RE: The following changes, additions, and/or deletions are hereby made a part of the *Water System Design and Construction Standards* dated November 2019 for projects designed for installation in the Tualatin Valley Water District's system, as fully and completely as if the same were set forth therein. The updates are now included in the document titled *Water System Design and Construction Standards* dated September 2020 and can be found on the District's website (www.tvwd.org/standards). All changes to the November 2019 document are listed below.

There are 24 pages included in this Addendum No. 1.

REVISIONS:

602

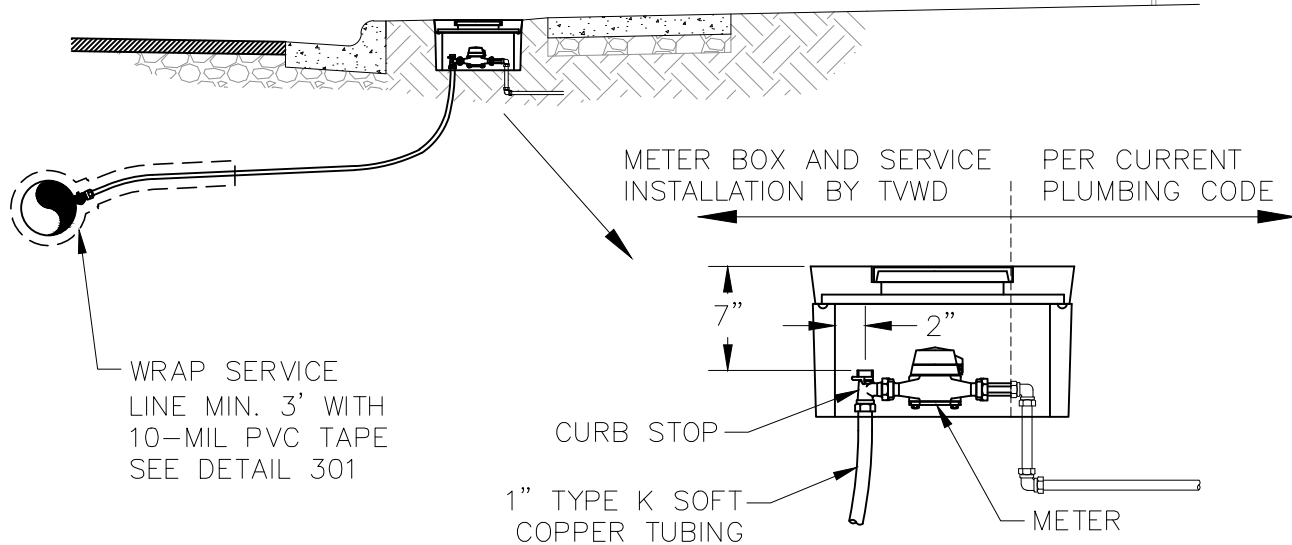
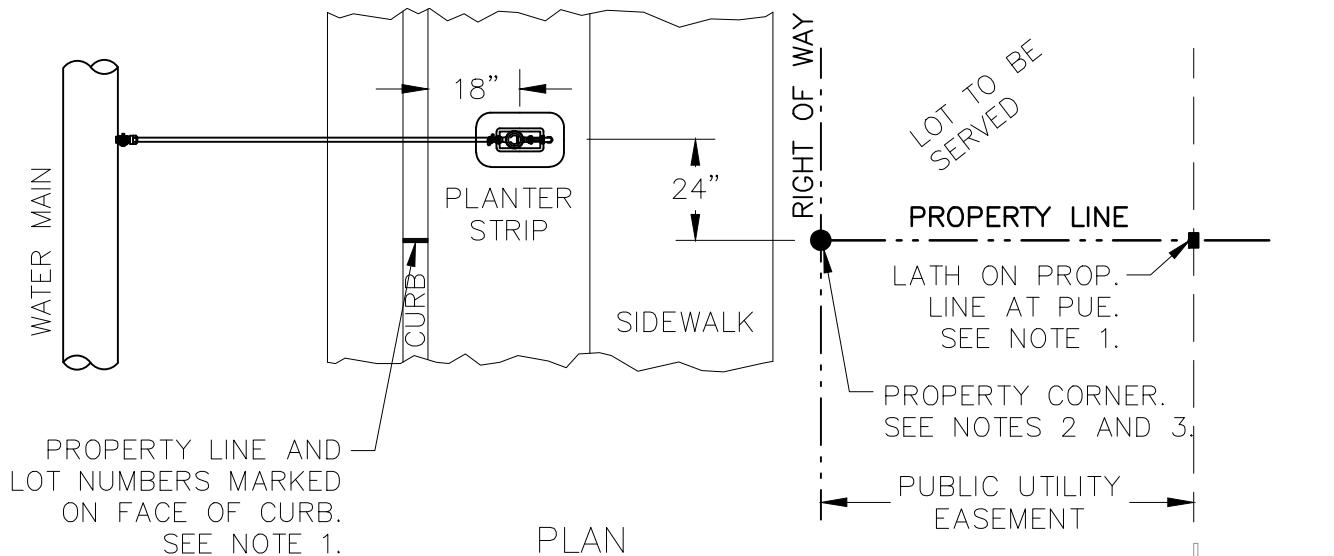
33. Modified Details 601-604 to call out "SEE SECTION 8.2 OF THE STANDARDS FOR BACKFLOW REQUIREMENTS" in the notes.
 34. Modified Details 606-610 to remove Note 4 "PAINT INTERIOR WALLS AND LID BOTTOM WHITE."

1. DEVELOPER'S SURVEYOR SHALL SET A LATH AT THE INTERSECTION OF THE PROPERTY LINE AND THE PUBLIC UTILITY EASEMENT. DEVELOPER'S SURVEYOR SHALL ALSO MARK THE PROPERTY LINE AND LOT NUMBERS ON THE FACE OF CURB WITH WHITE PAINT.
2. IF PROPERTY CORNER MONUMENTS HAVE NOT BEEN SET AT THE TIME OF WATER SERVICE INSTALLATION, THE DEVELOPER'S SURVEYOR SHALL SET A LATH AT THE PROPERTY CORNER LOCATION ON THE RIGHT-OF-WAY LINE.
3. ORS 92.044(7) PROHIBITS LOCATING ANY UTILITY INFRASTRUCTURE WITHIN 1 FOOT OF A SURVEY MONUMENT. DEVELOPER SHALL PAY FOR ANY RELOCATION OF SERVICES AND/OR METER BOXES FOUND TO FALL WITHIN 1 FOOT OF A SURVEY MONUMENT LOCATION.
4. SEE SECTION 8.2 OF THE STANDARDS FOR BACKFLOW REQUIREMENTS.

606

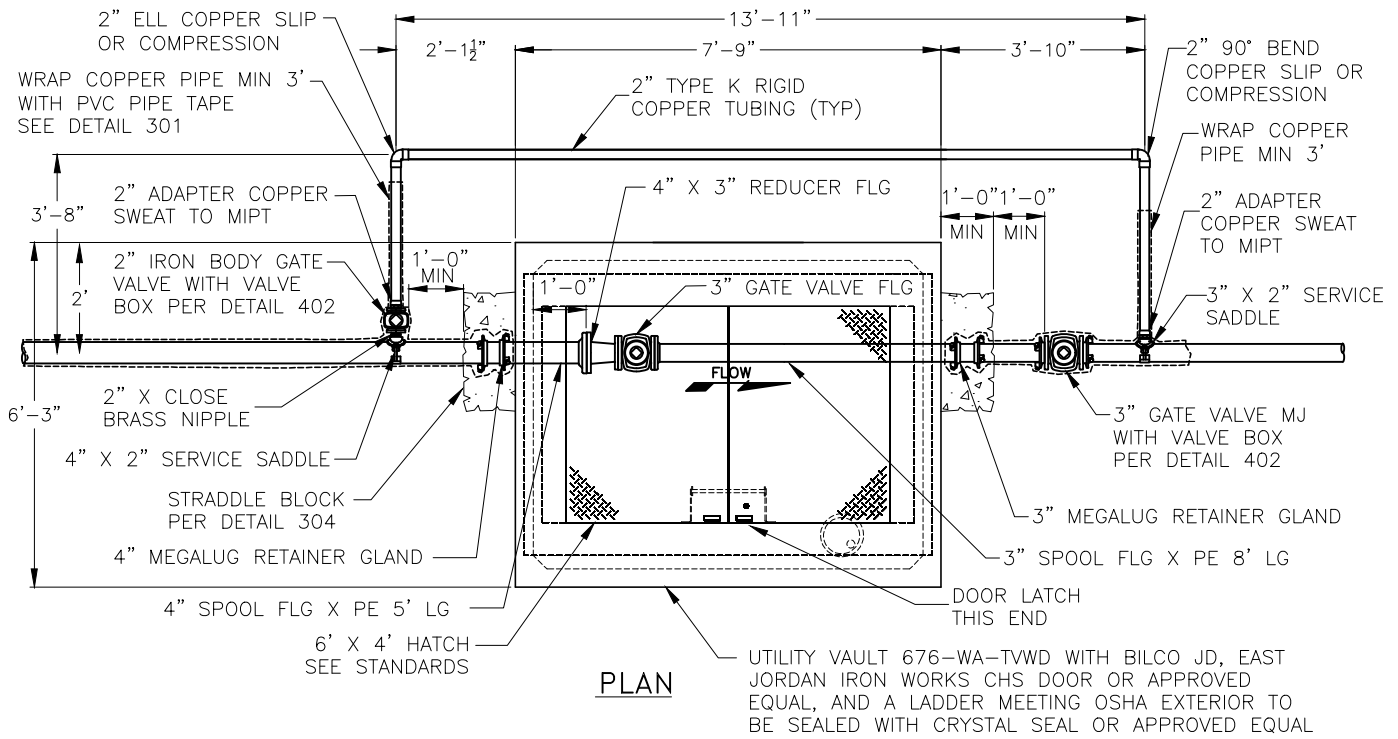
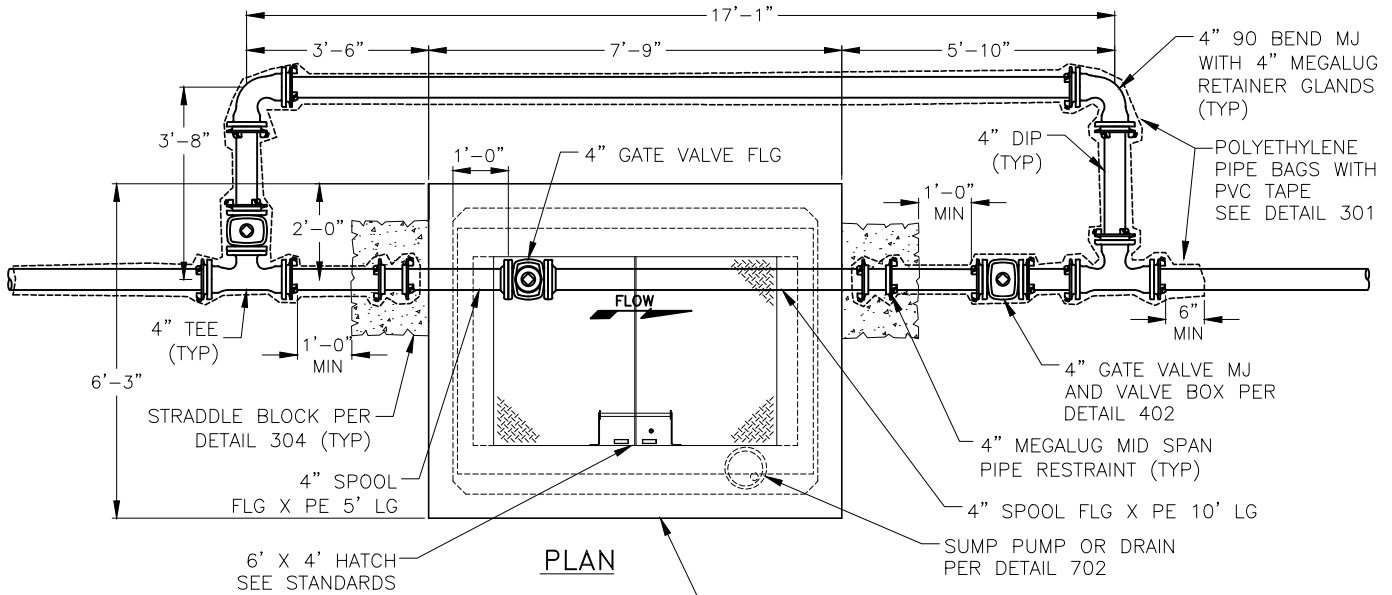
22. Deleted Section 7.2.I. “Interior Paint” on Page 7-4 in the Standards and Note 4 on Details 606-610.
 23. Modified Section 8.4.A.2.b. to reference “mega flange coupling adapter” and add “Inlet spool shall be flange by plain end, refer to Detail 801.”.

701

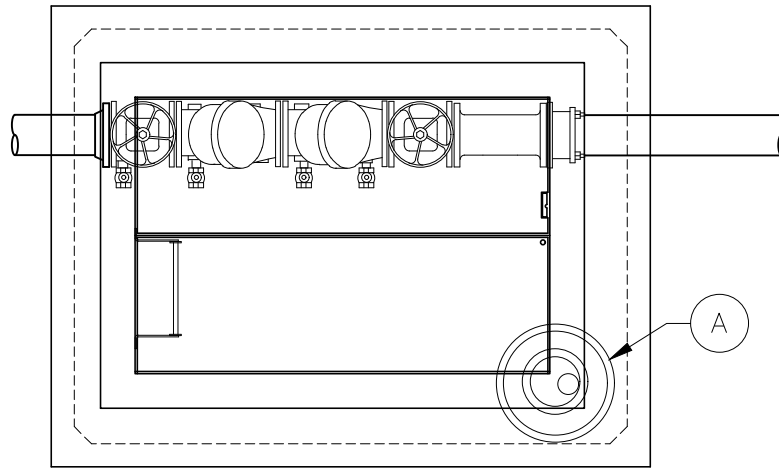
35. Modified Detail 701 Keynote A to replace "BILCO TYPE LU-2" with "BILCO TYPE LU-4".
 36. Modified Detail 702 Notes G and H, added "NOT APPLICABLE IF SUMP PUMP IS INSTALLED."

- A. LADDER EXTENSION SHALL BE ALUMINUM AND EXTEND 40" ABOVE THE TOP OF THE VAULT OPENING. LADDER UP POST SHALL BE BILCO TYPE LU-4 OR APPROVED EQUAL.
- B. ATTACH LADDER SUPPORT TO INSIDE FACE OF VAULT COVER OPENING WITH STAINLESS STEEL HARDWARE AS SHOWN. ϕ OF RUNG MUST BE SET 7" FROM FACE OF SURFACE BEHIND RUNG. LADDER SHALL BE ON THE SIDE ADJACENT TO THE DOOR HINGE.

703

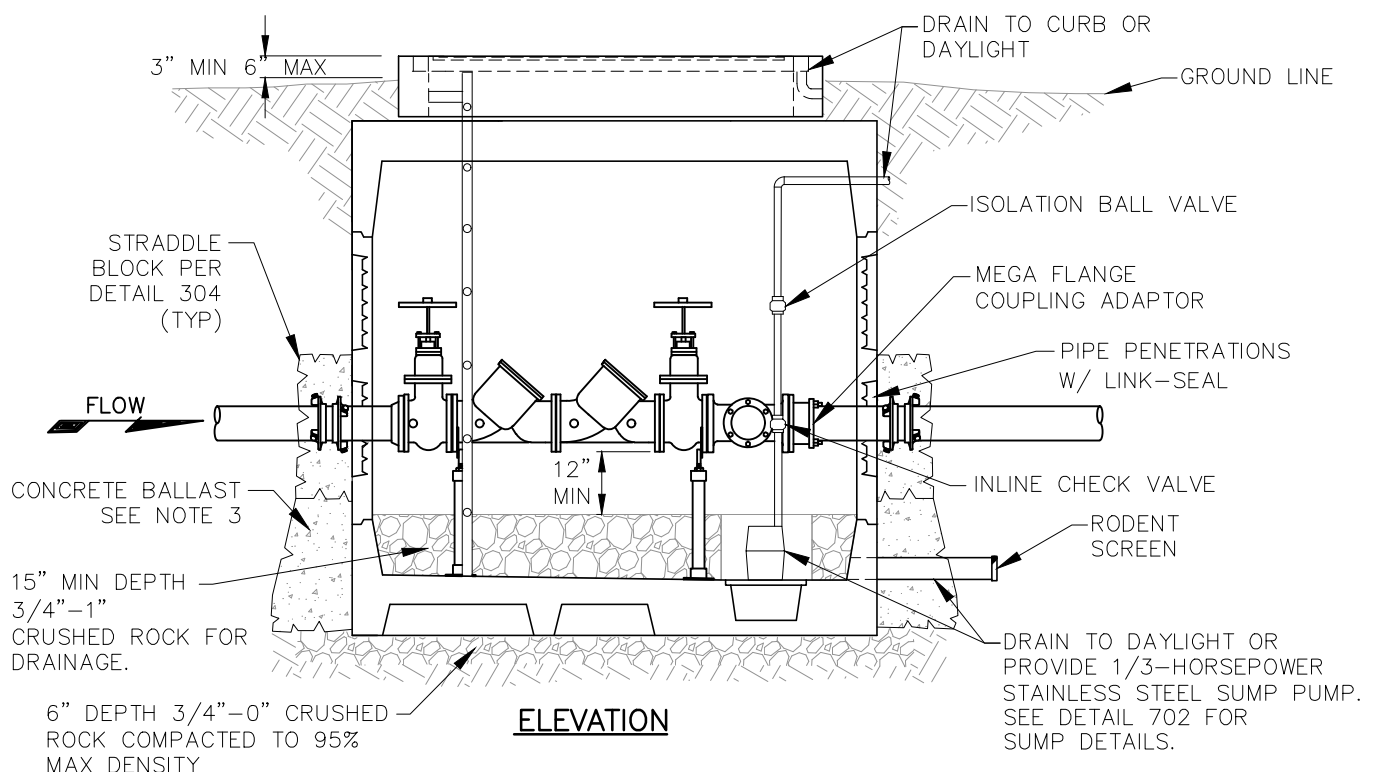
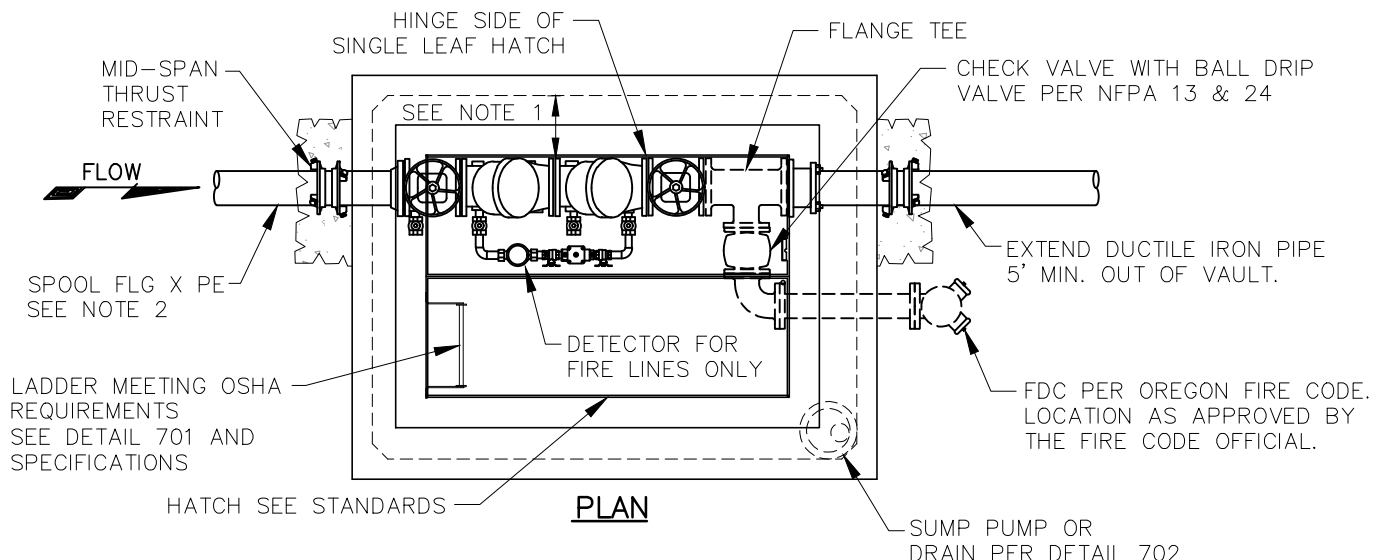
37. Modified Detail 703 to call out "1" COPPER TUBING" replacing "COPPER TUBING". Added Note 10 "PROVIDE SCHEDULE 40 PVC PIPING AND FITTINGS TO CONNECT BOTH THE SUCTION AND OUTLET OF THE SUMP PUMP". Added Note 11 "BENDING OF COPPER TUBING IS PERMITTED. KINKS IN TUBING ARE NOT ALLOWED."

9. 18" MIN. DIAMETER PVC PIPE, PERFORATE FIRST 1'-0" AND WRAP PVC PIPE WITH FILTER FABRIC TO PREVENT INTRUSION OF ROCKS.
10. PROVIDE SCHEDULE 40 PVC PIPING AND FITTINGS TO CONNECT BOTH THE SUCTION AND OUTLET OF THE SUMP PUMP.

11. BENDING OF COPPER TUBING IS PERMITTED. KINKS IN TUBING ARE NOT ALLOWED.
